***** IMPORTANT SAFETY RECALL *****
NHTSA Recall No. 19E020
Interim Recall Notice

Cummins Inc. has decided that a defect which relates to motor vehicle safety exists in certain B6.7 diesel engines that were manufactured between December 16, 2015 and February 25, 2019 and equipped with fuel module option FS90301 or FS90453.

Figure 1 - Location of Fuel Filter Module & Heating Element

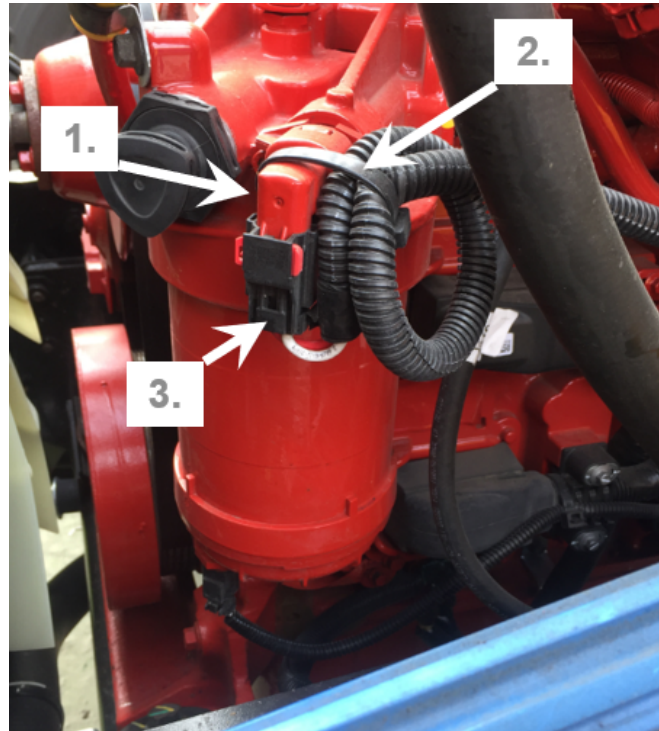
- Locate the fuel filter module and fuel heater at the driver's side front of the engine as shown in Figure 1 below.
- Inspect the heater and module for any signs of damage or fuel leakage.
- If there is no damage or leakage after engine shutdown, remove the fuel heater fuse as shown in Figures 2 or 3 below (based on application) and leave the wiring harness connected.
- In the event there are signs of damage OR leakage, contact your local Cummins service location at the number below to have a heater plug kit installed. (Reference TSB190038)

Figure 2. Navistar® CE Bus Fuse Removal Instructions

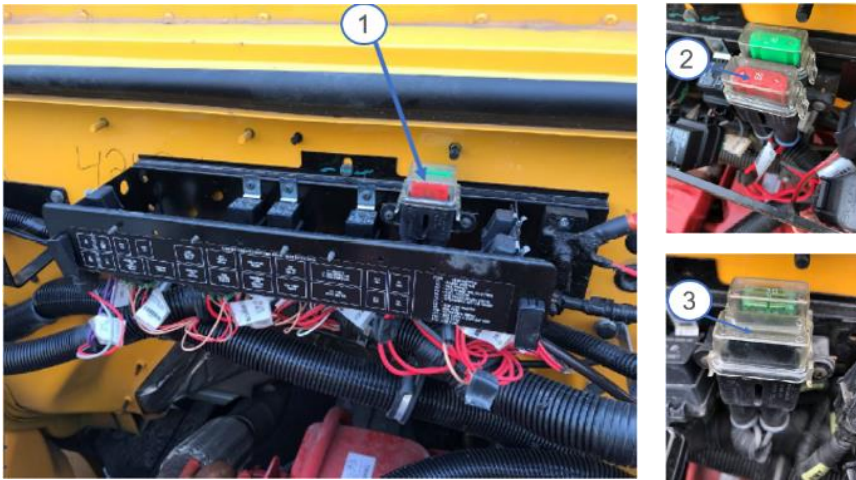
1. Locate red Maxi Fuse on dash panel. See Figure below.
2. Remove fuse cap and discard red Maxi Fuse. See Figure below.
3. Reinstall fuse cap. Do **not** replace fuse. See Figure below.
4. Retain fuse for reinstallation once final remedy is performed.

Figure 3. Navistar® MV/HV Fuse Removal Instructions

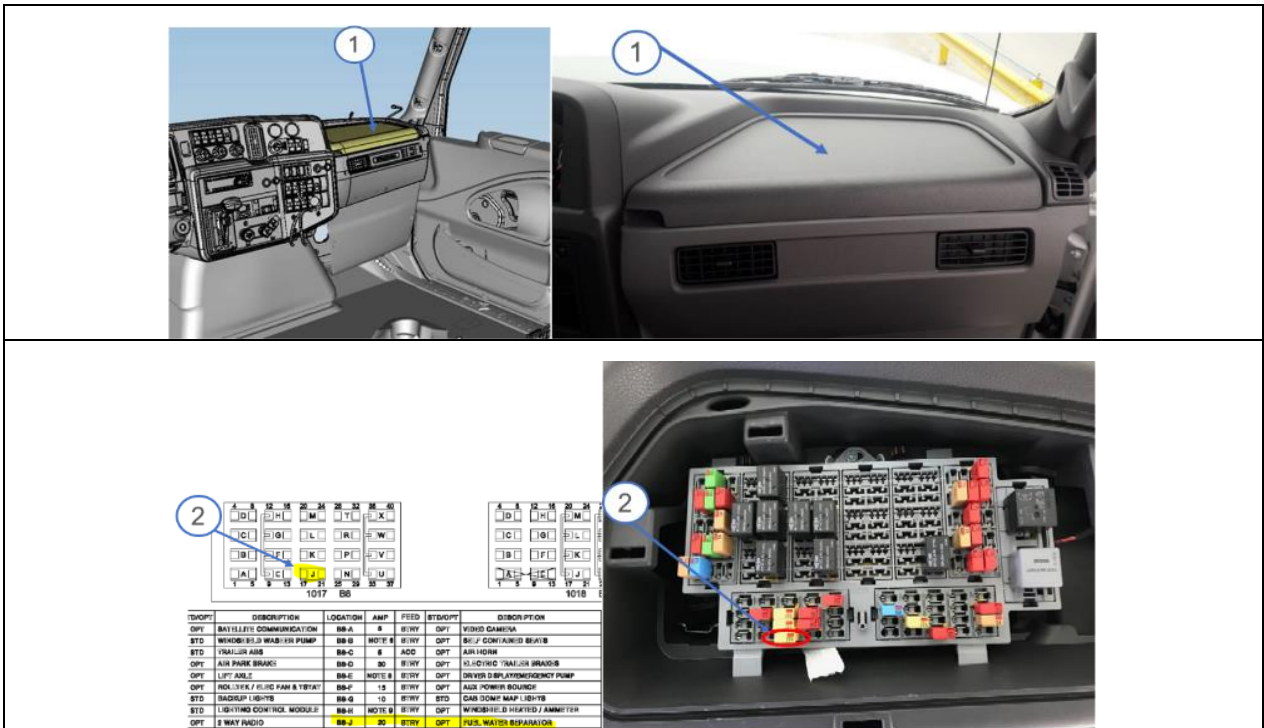
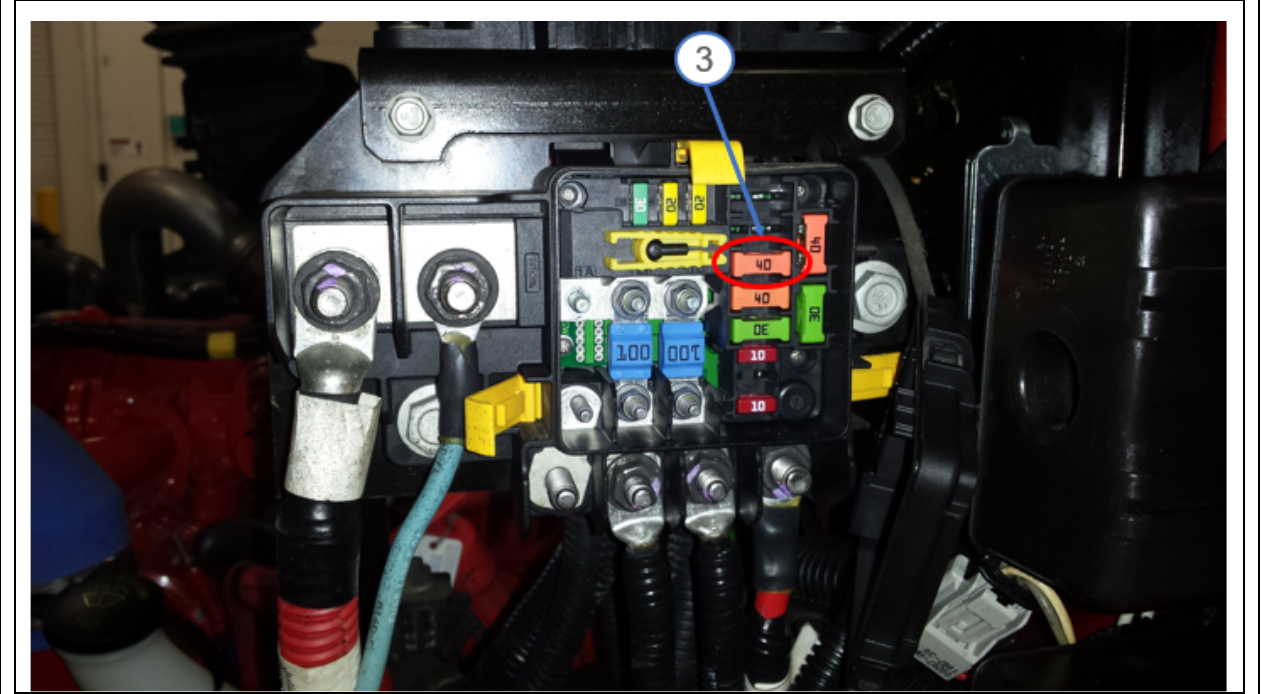
1. Remove cover of fuse box, located on passenger side dashboard as indicated in the photo below.
2. Remove 20 amp fuse located at B8-J cavity 17-21 as indicated in the photo below.
3. Remove 40 amp fuse located at 2C cavity as indicated in the photo below..
4. Retain fuses for reinstallation once final remedy is performed.
